## Keeyask Generation Project

### Request to Release Impounded Water with TSS Concentrations Greater than 25 mg/L in Spring 2017

**SUBJECT** **KEYYASK GENERATION PROJECT – SEDIMENT PLUME MODELING OF  
POTENTIAL HIGH TSS DISCHARGES DURING SPRING PUMPING (REV 0)**

**Subject:** Discharge of snow meltwater from cofferdams

Map 1 – Keyyask Construction Site and Pumping Discharge Locations.

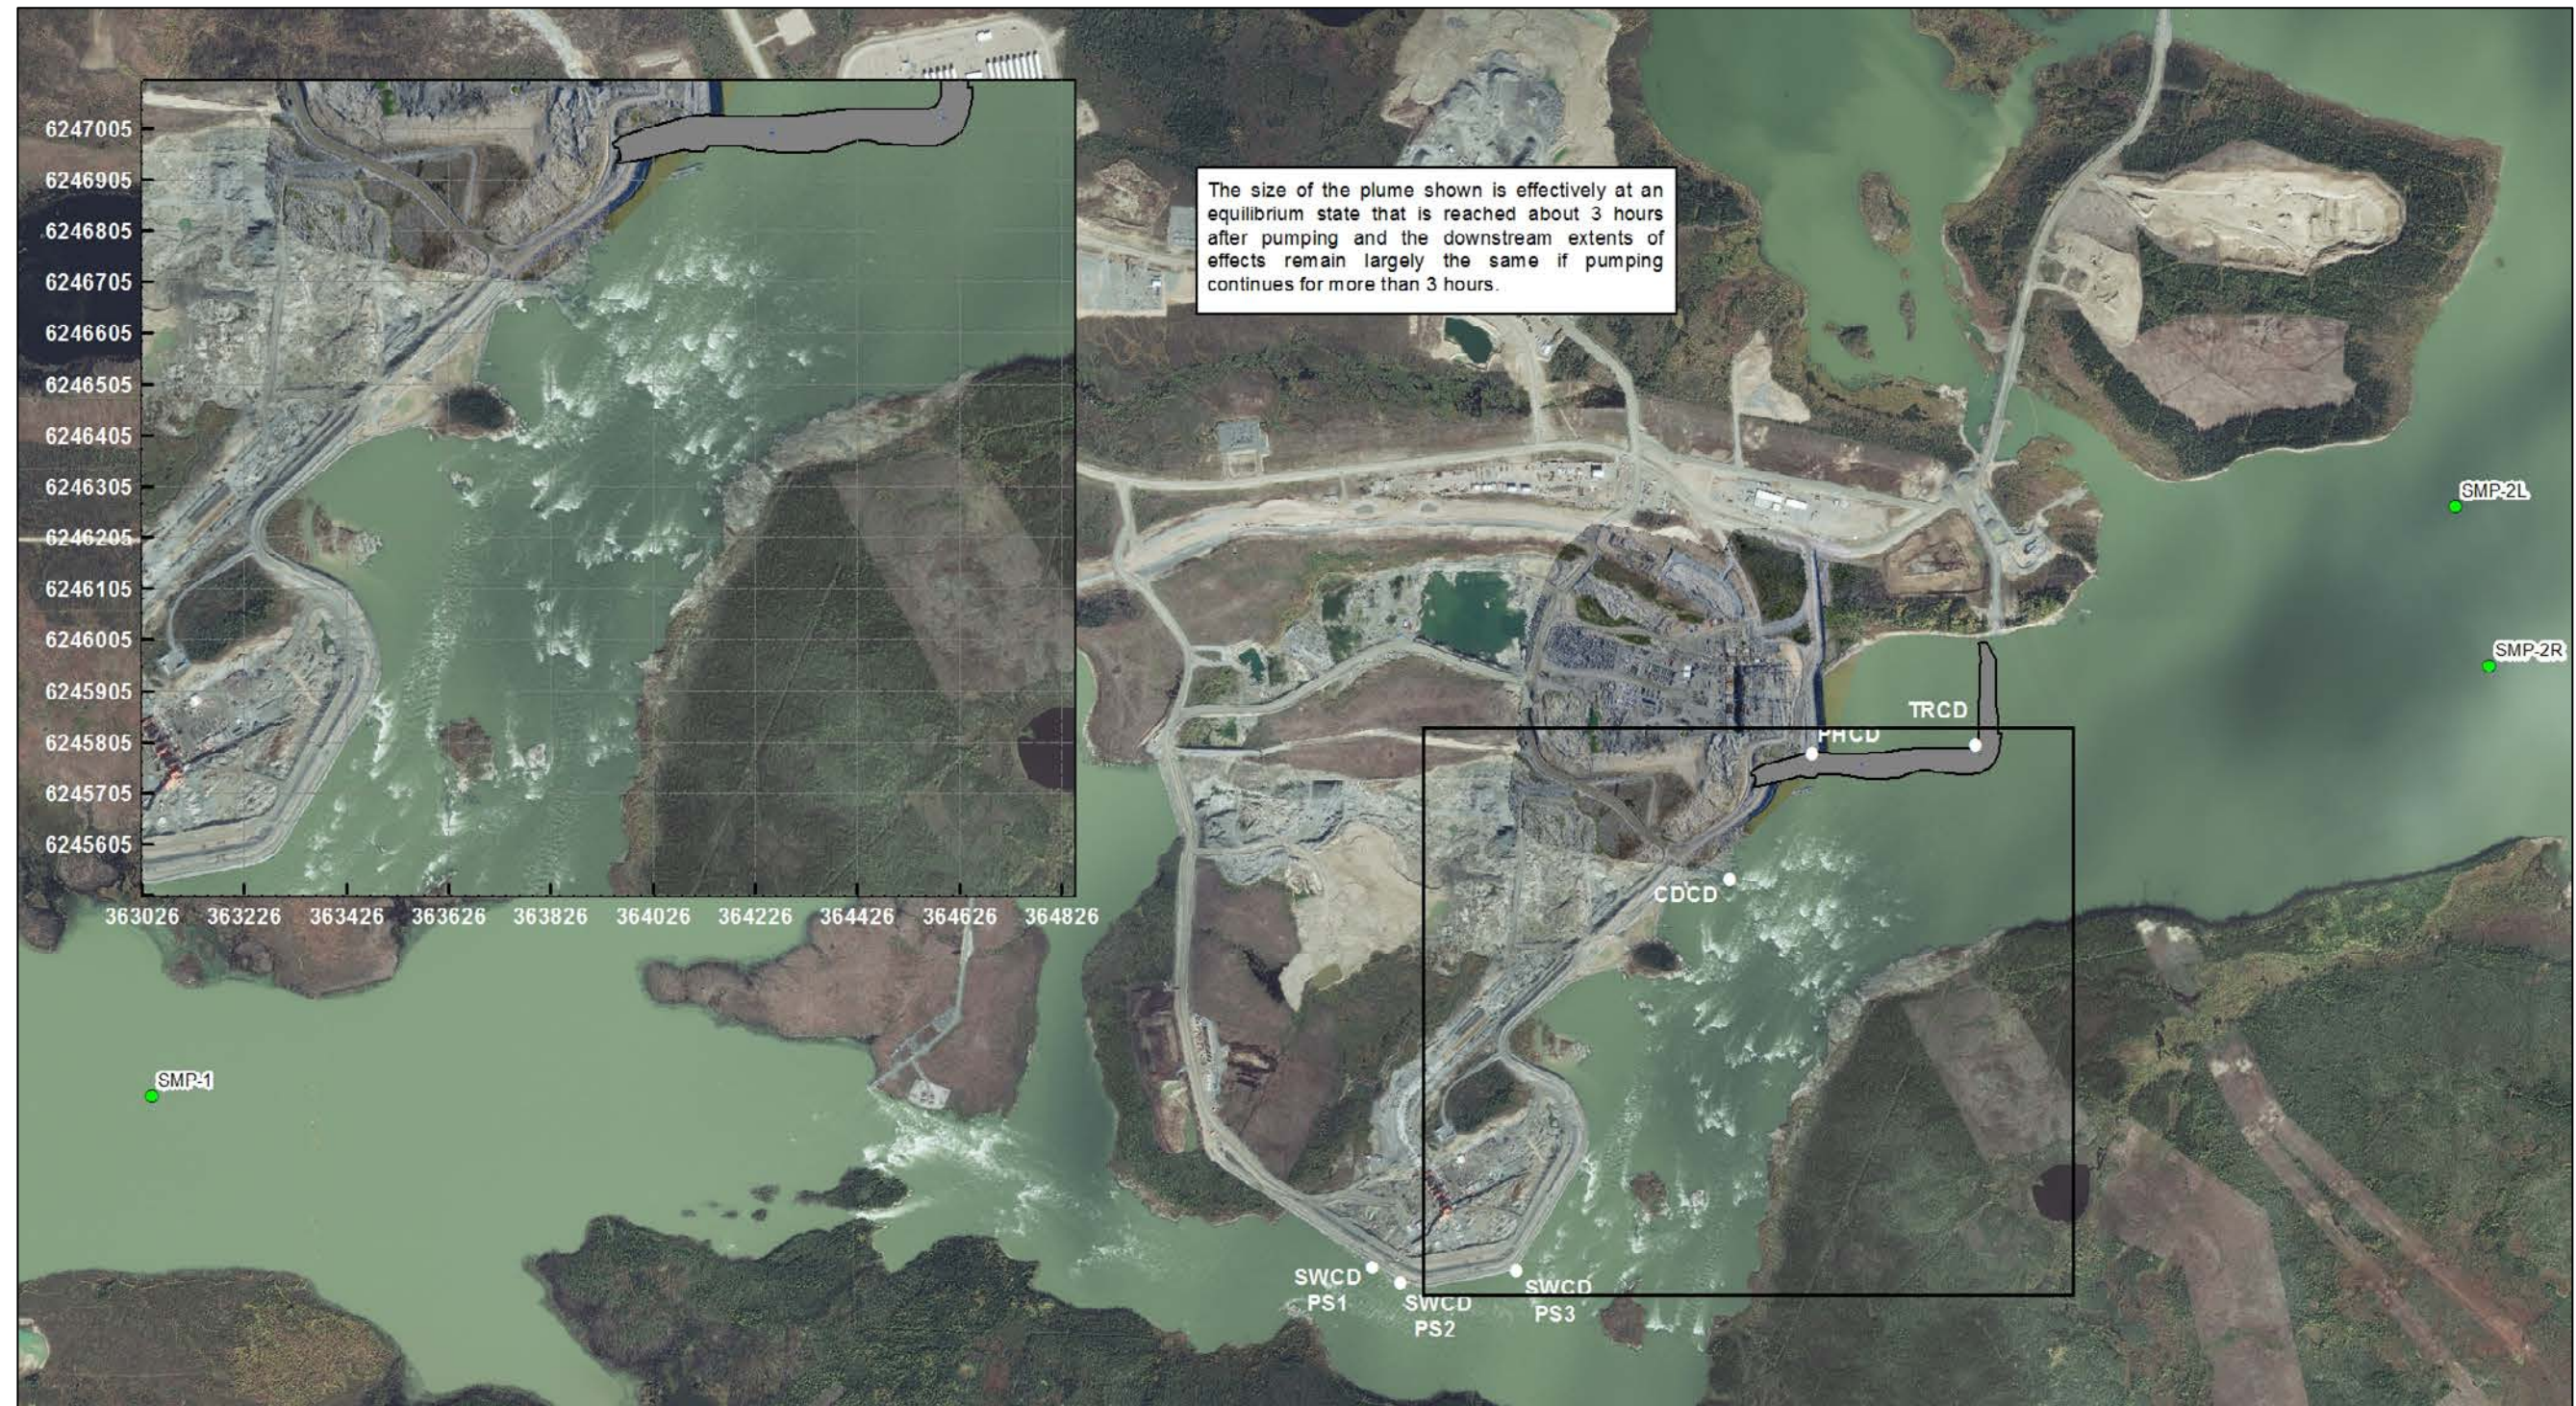
The very high river flow causes rapid mixing at each discharge location. Thus, even though the end-of-pipe TSS is 50 mg/l and twice the desired limit, the model does not show any discernible areas in the river in which TSS increases by more than 5 mg/l.
